CDA PROJECT NUMBER
220166

PROJECT NAME
**O'HARE SATELLITE
CONCOURSE 1**

S1 ENLARGED
BUILDING SECTIONS

A5.2.E.02

Concourse Ceiling

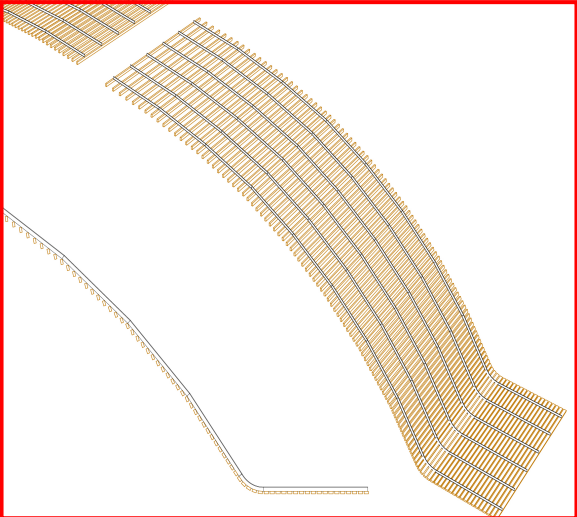
1. Is it intended that these sections of ceiling are provided as panelized assemblies or individually hung wood slats?

Holdroom Conceptual Ceiling Design

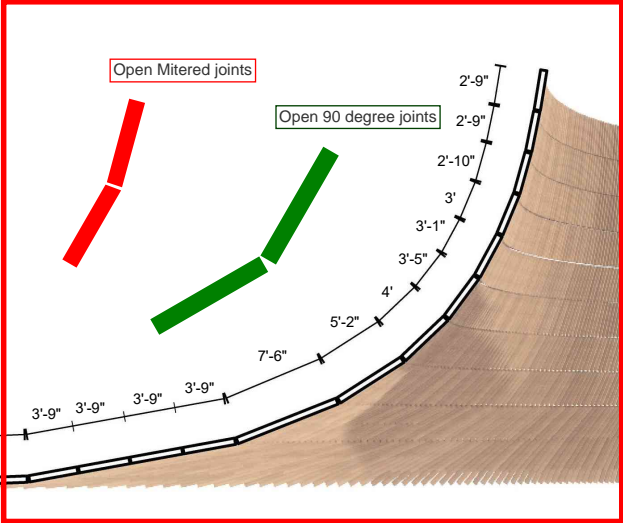
- 2. Is there an intended or required type of suspension system for these ceilings?
- 3. Can additional suspension be added to meet product cantilever requirements?
- 4. Does the design intent require having continuous wood slats for the length of each bay? Or can they be broken up with respect to material length availability?
- 5. Are there any access requirements for this section of ceiling?

Wood Veneer Ceiling in Station

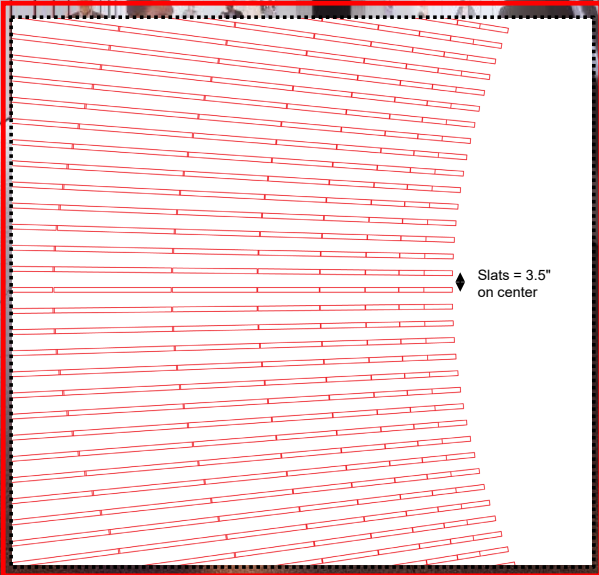
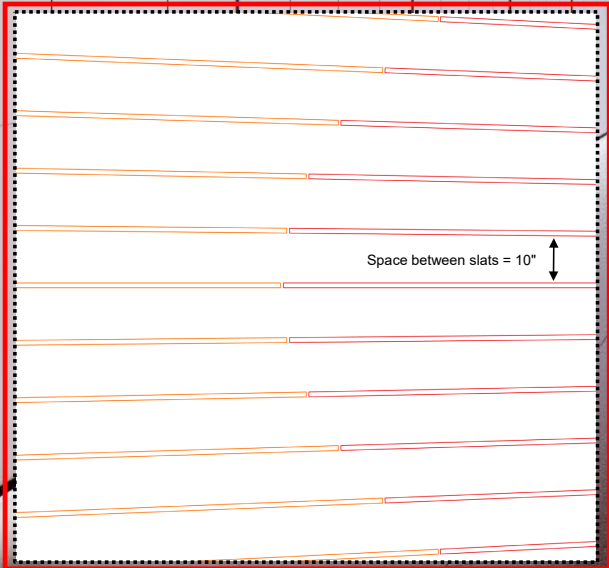
6. What is the intended end to end joinery between the slats as they transition up the wall?

1 APM PLATFORM SECTION
1/8" = 1'-0"

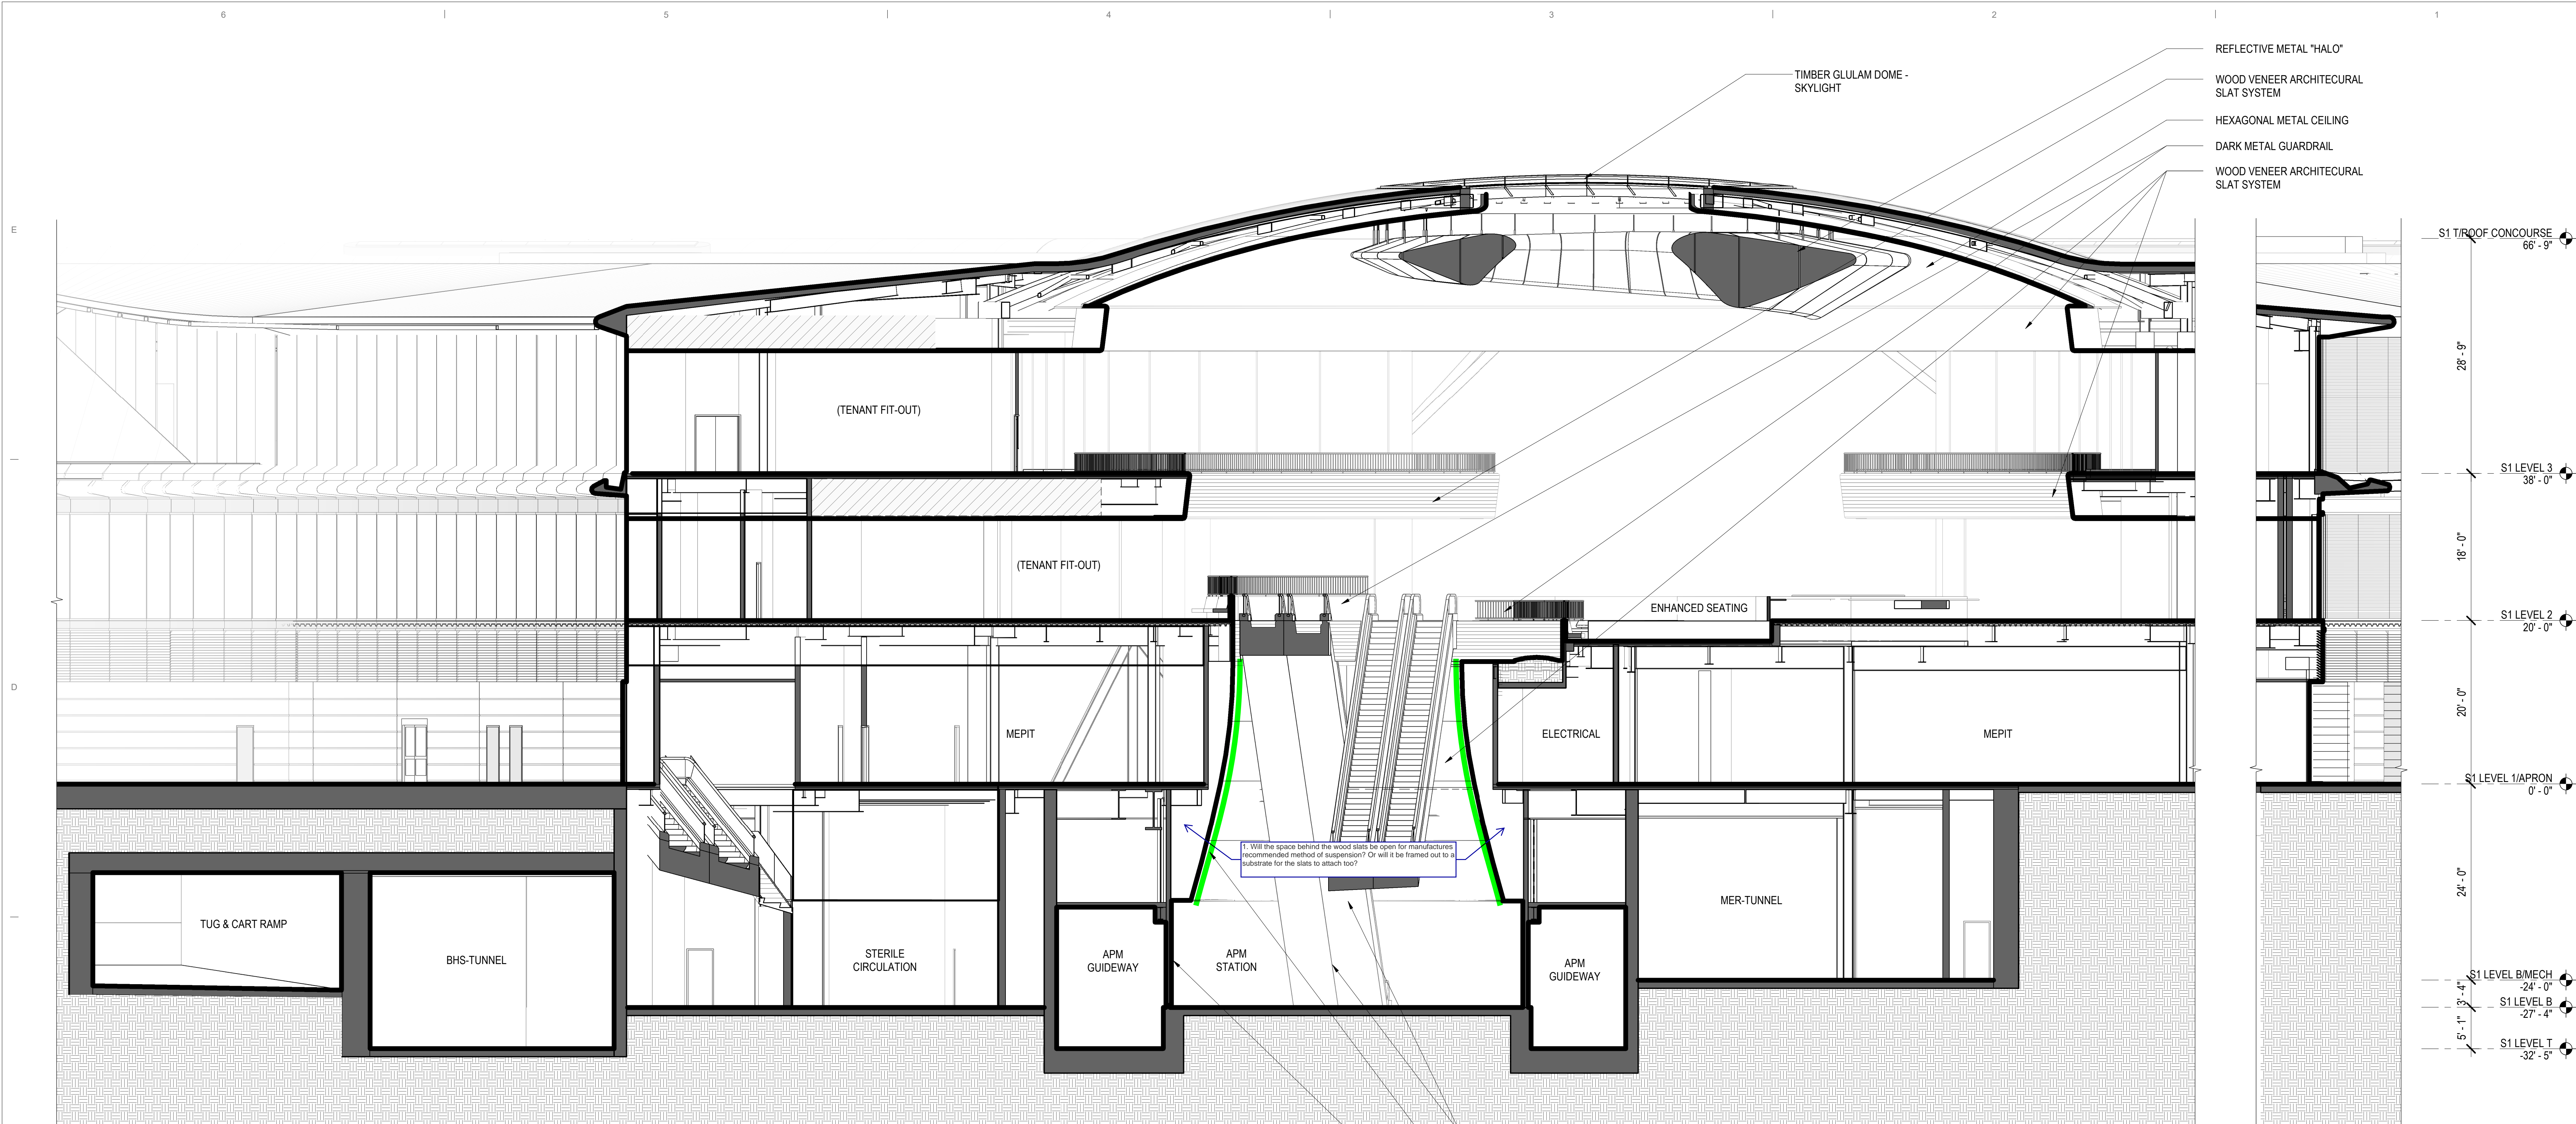
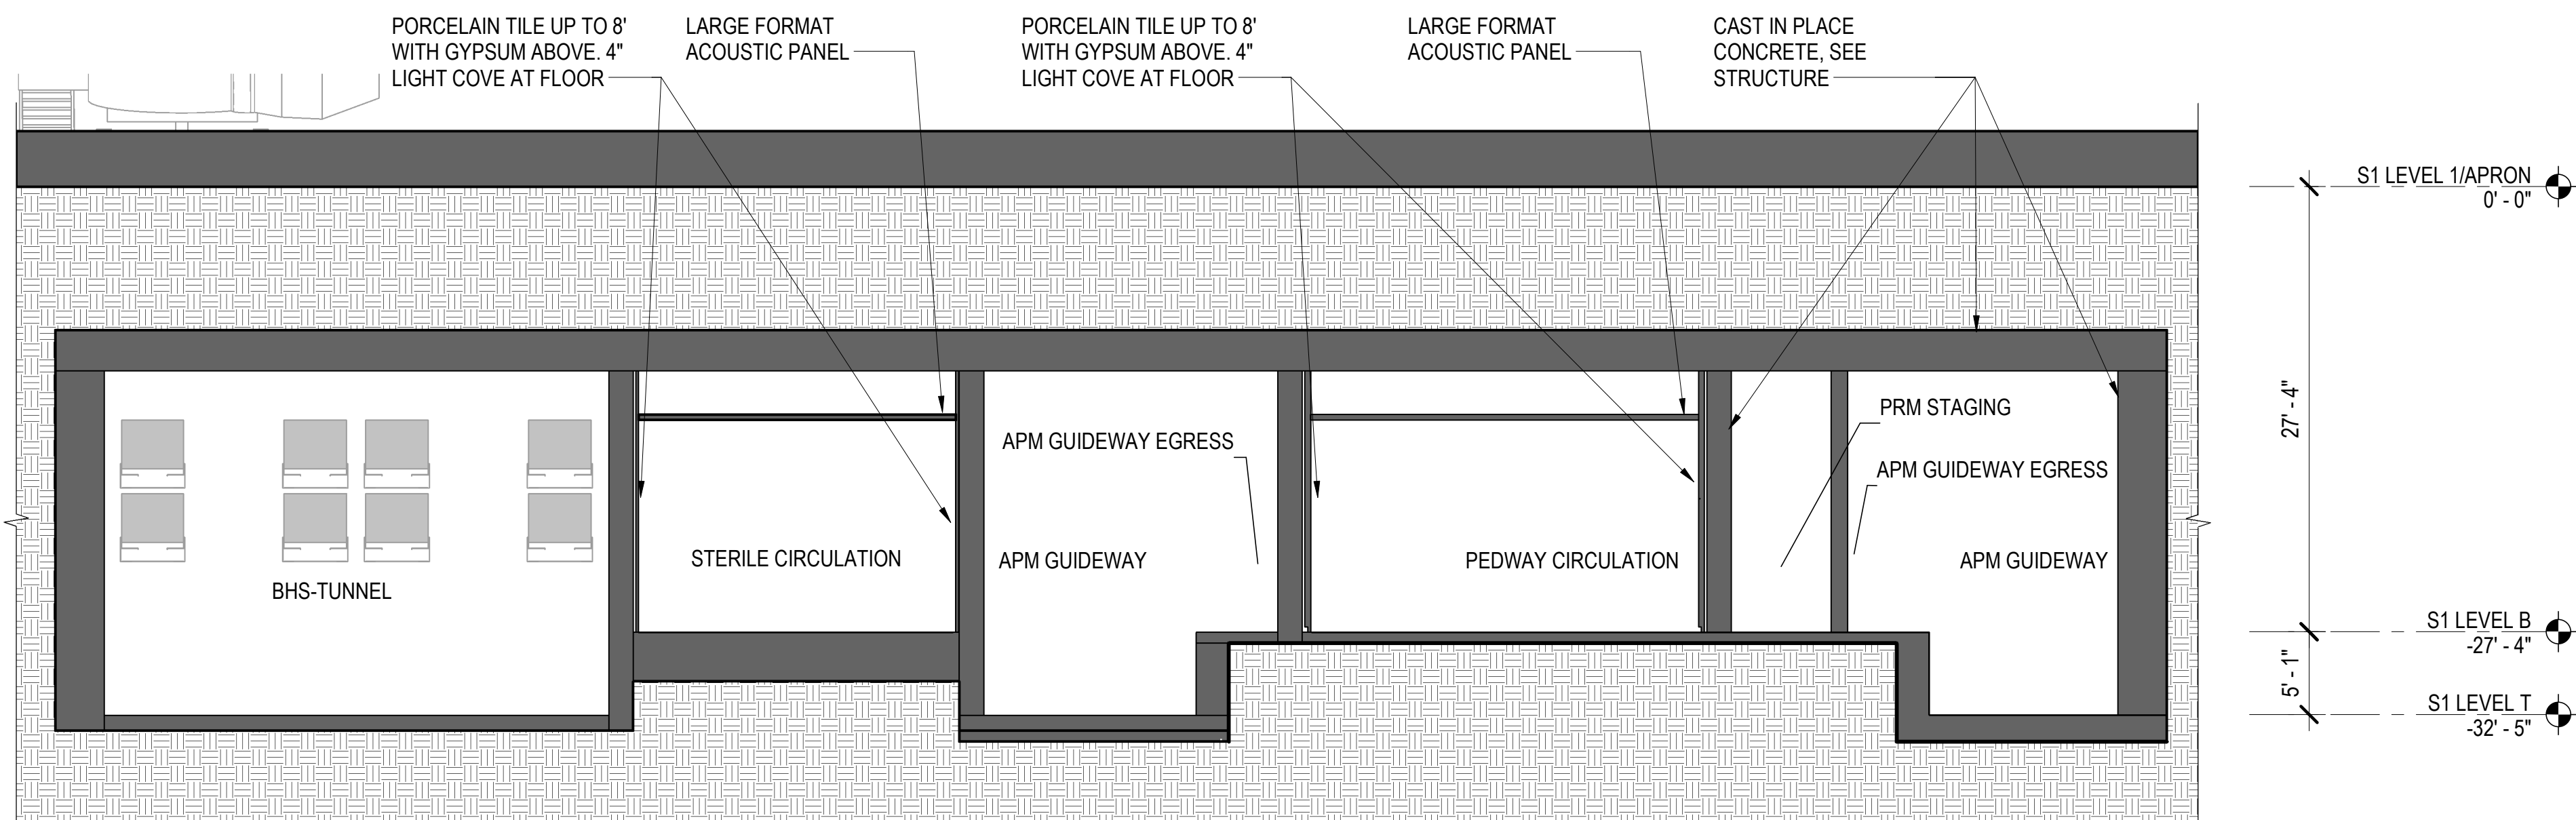
1. Is it intended that these sections of ceiling are provided as panelized assemblies or individually hung wood slats?
2. Can it be open from between the slats and into the plenum space? Or does the surface directly behind the slats need to block off the plenum?
3. Is there an intended or required type of suspension system for this ceiling to wall system?
4. Are there any access requirements for this section of ceiling and/or wall upturns?
5. Are there acoustical requirements for this section of ceiling and wall?

Underside Sterile Corridor Ceiling

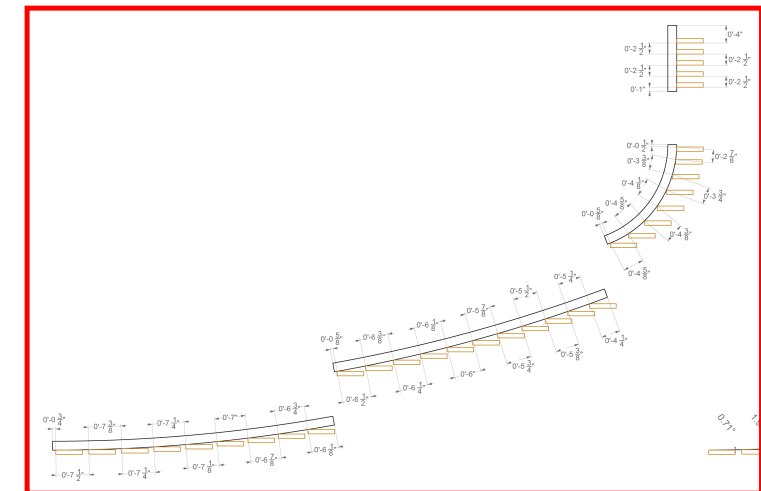
1. Is it intended that these sections of ceiling are provided as panelized assemblies or individually hung wood slats?
2. Can it be open from between the slats and into the plenum space? Or does the surface directly behind the slats need to block off the plenum?
3. Is there an intended or required type of suspension system for these ceilings?
4. Can additional suspension be added to meet product cantilever requirements?
5. Does the design intent require having continuous wood slats for the length of each bay? Or can they be broken up with respect to material length availability?
6. Is there any flexibility in the depth/width of the slats?
7. Are there any access requirements for this section of ceiling?

6.0 Node Typical Slab Edge & Guardrail Detail

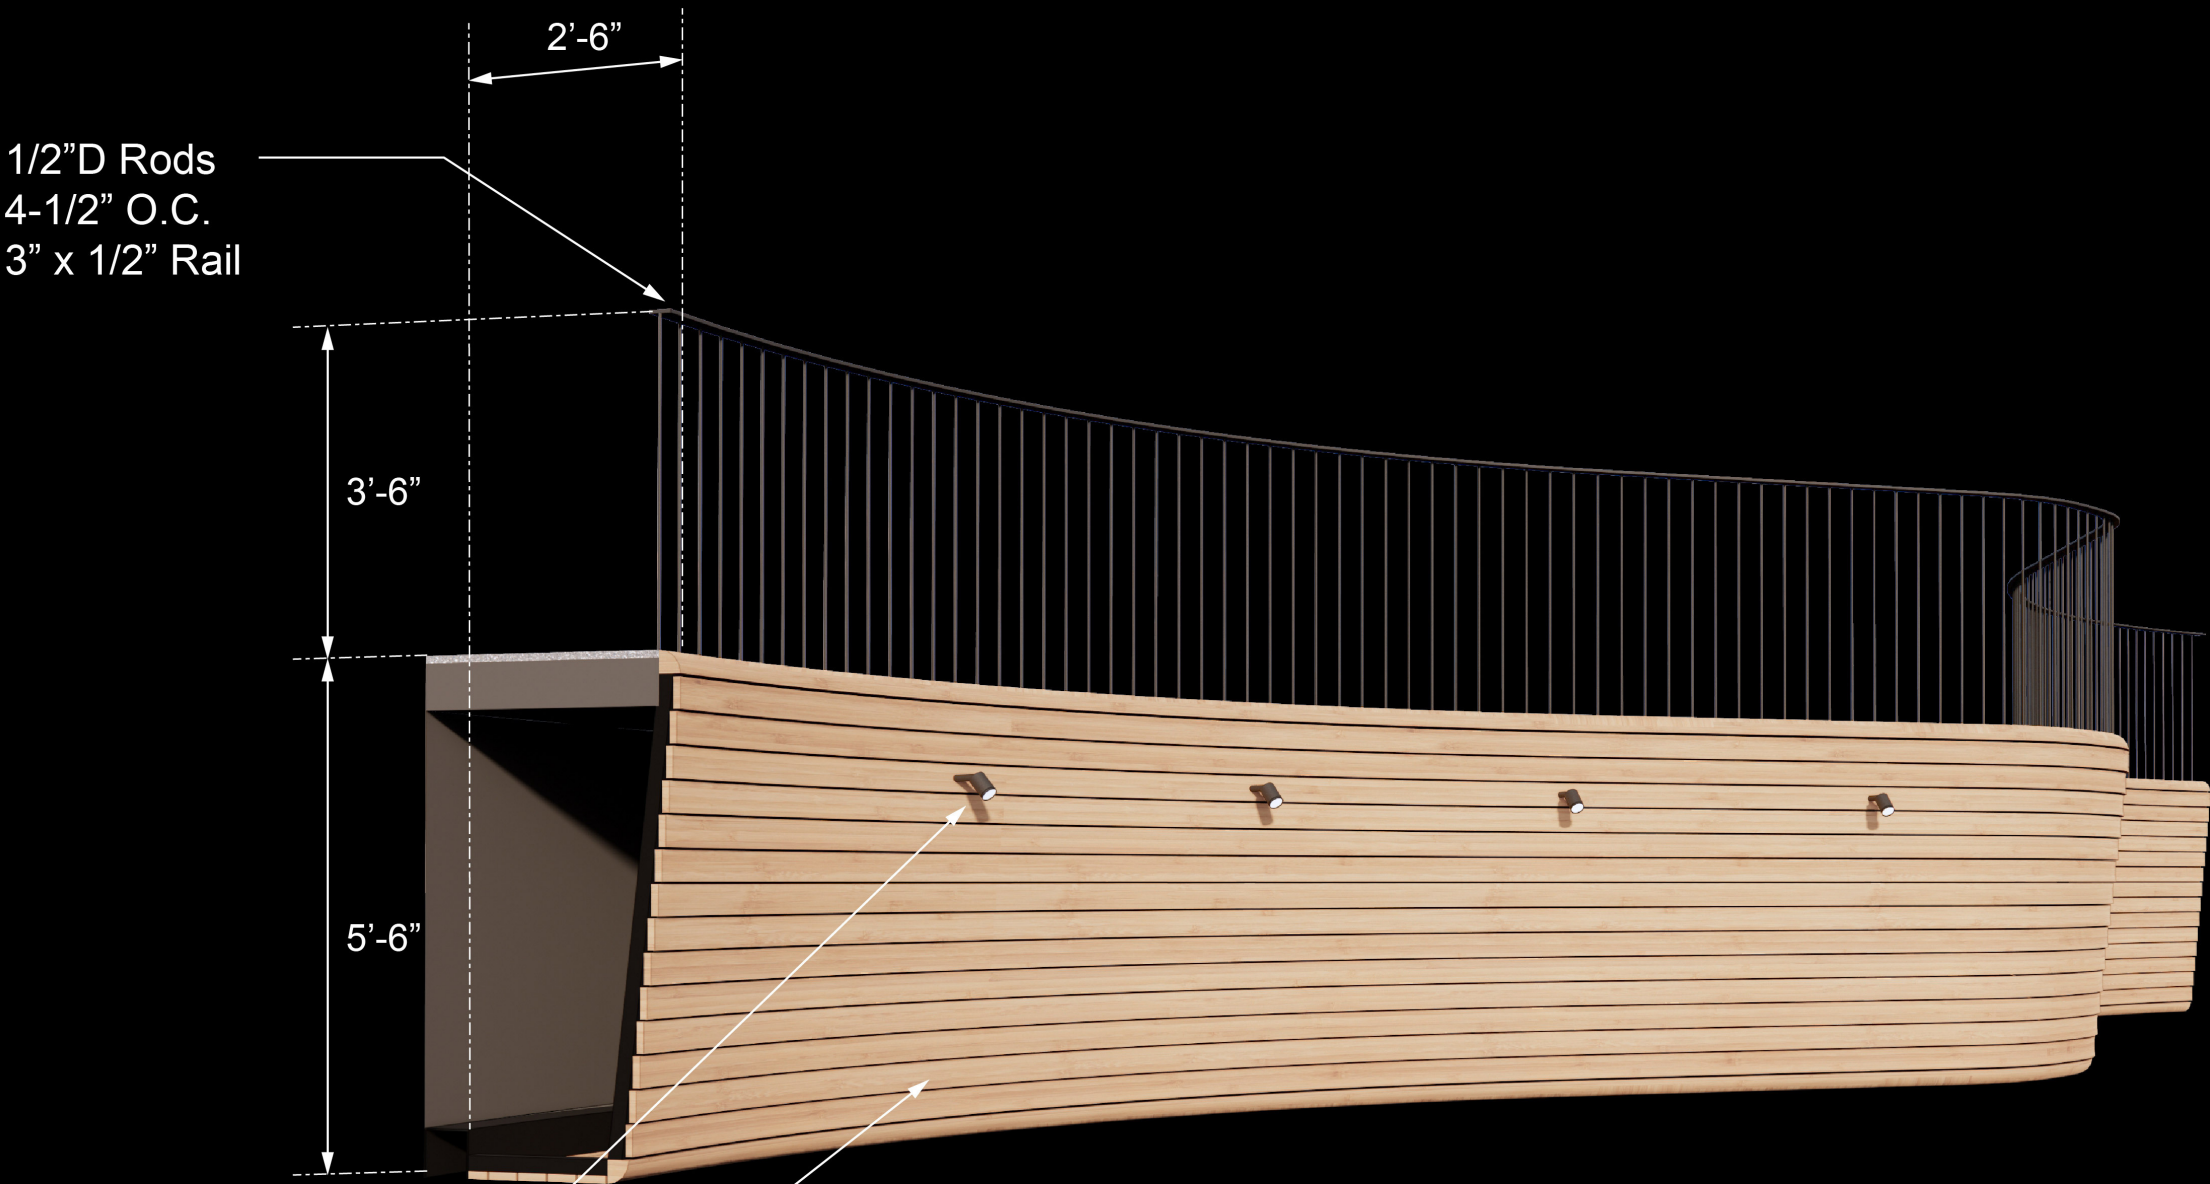
1. For the wall application, is there flexibility in the gap size and offset to accommodate means of concealed attachment and tolerances?
2. The bullnose edge detail presents significant constructibility challenges. Is the design open to alternative solutions?
3. The renderings appear to have the wood slats for both the wall and ceiling as continuous. Is the design open to breaking these up with gaps between board ends to accommodate material length availability?
4. What will the buildout look like behind the wall application? Will it be framed, or open for a preferred recommended suspension system of the wood system?
